SUBDIVISION REVIEW SHEET**CASE NO.:** C8-2022-0267.0A**COMMISSION DATE:** December 6, 2022**SUBDIVISION NAME:** Resubdivision of Lot 1-A**ADDRESS:** 11801-1/2 Research Blvd Service Road**APPLICANT:** Karlin Duval, LLC (Matthew Schwab)**AGENT:** HRGreen Development TX (Joe Isaja)**ZONING:** LI, LI-CO (Limited Industrial)**NEIGHBORHOOD PLAN:** n/a**AREA:** 35.2 acres (1,533,312 sf)**LOTS:** 8**COUNTY:** Travis**DISTRICT:** 6**WATERSHED:** Walnut Creek**JURISDICTION:** Full Purpose**SIDEWALKS:** Sidewalks along state maintained property must be approved by TxDOT.**VARIANCE:** None**DEPARTMENT COMMENTS:**

**CITY OF AUSTIN –DEVELOPMENT SERVICES DEPARTMENT
SUBDIVISION APPLICATION – MASTER COMMENT REPORT**

CASE NUMBER: C8-2022-0267.0A
 UPDATE: U0
 CASE MANAGER: Nicholas Coussoulis Email: Nicholas.Coussoulis@austintexas.gov

PROJECT NAME: Resubdivision of Lot 1-A
 LOCATION: 11801-1/2 RESEARCH BLVD SVRD NB

RESEARCH BLVD
(N US 183)

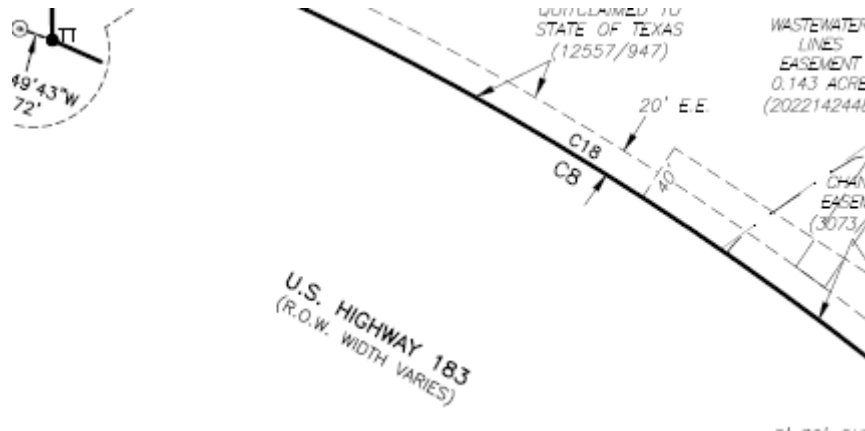
AD3: Please change the label for Anderson Lane appears as E ANDERSON LN so that E ANDERSON LN appears above the label US HIGHWAY 183. US HIGHWAY 183 should be enclosed within parenthesis and not be bold.

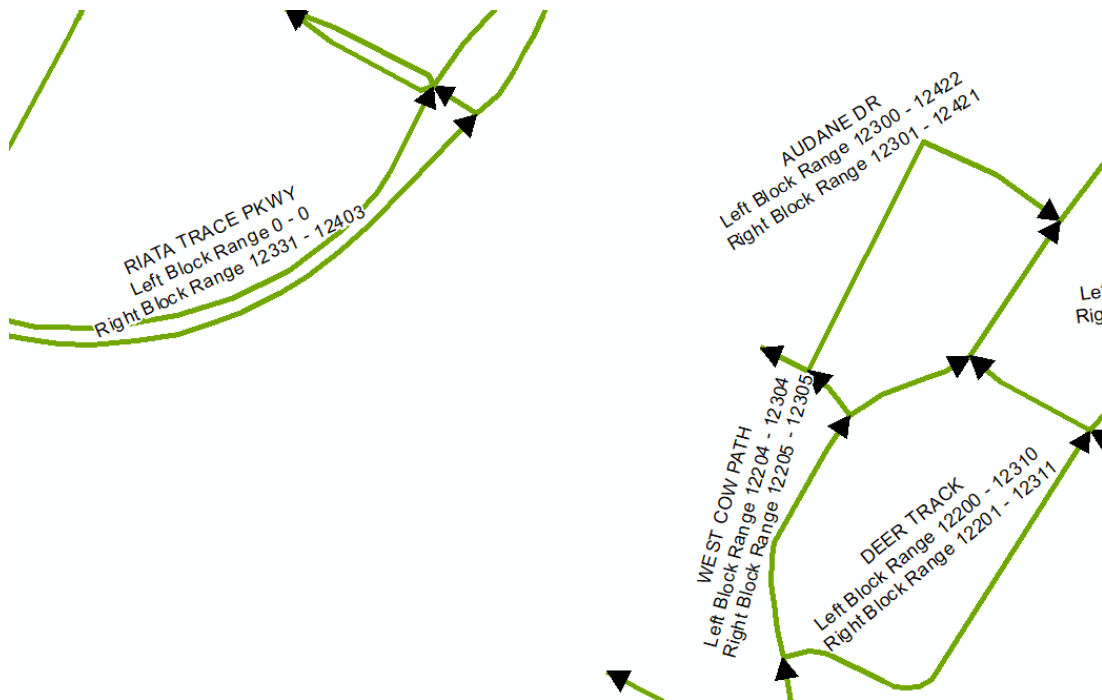
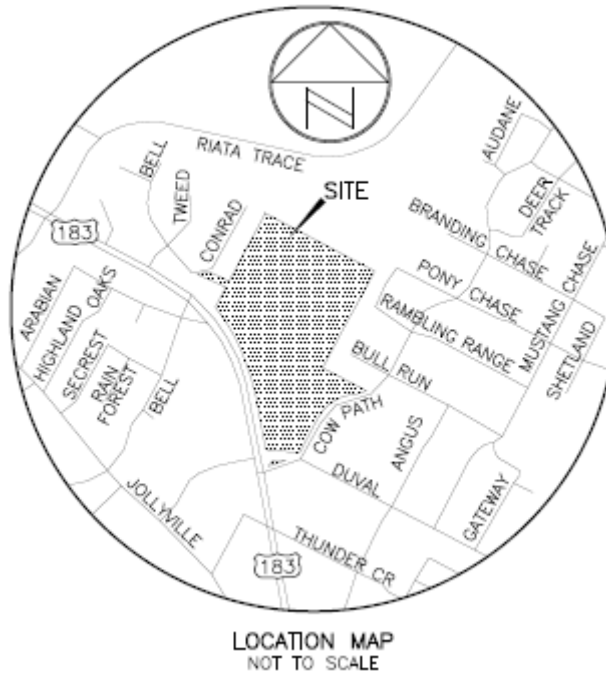
AD4: Please update labels for all streets in the location map the street types must be included

AD5: Please update label for **WEST COW PATH** in the location map the full name must be included

Overall Wetland CEFs:

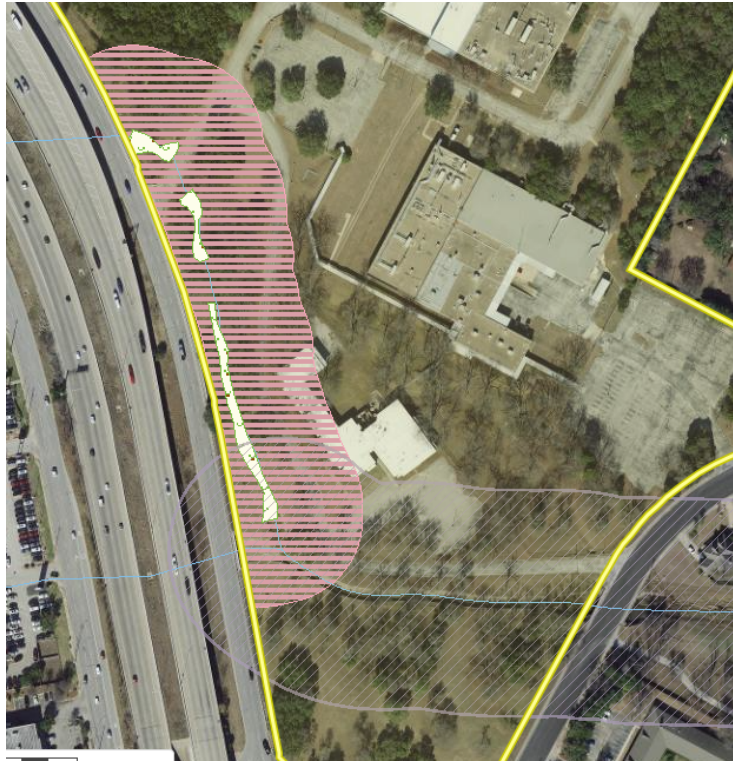
FYI Three wetland CEFs (BRG IDs 207775, 207776 and 207777) were previously identified and field verified by WPD staff. These three CEFs coincide with the wetland CEFs identified in the ERI conducted by Terracon (dated July 2019). Please the screenshots of the approximate location and boundaries of the wetland CEFs on Property Profile Tool. In addition, the Shapefiles for the wetland CEFs are available on Property Profile to be downloaded.

WB1. Update0. Please demonstrate compliance with LDC 25-8-281 or 30-5-281; LDC 25-8-282 or LDC 30-5-282.

Additional information: {This reviewer cannot establish wetland CEF protection provisions. e.g. Clearly show the boundary of the wetland CEFs and clearly label the features: "WETLAND CEF" on all plat sheets where they exist. Please show the wetlands as shown in the Environmental Resource Inventory and on Property Profile Tool see screenshots above.}
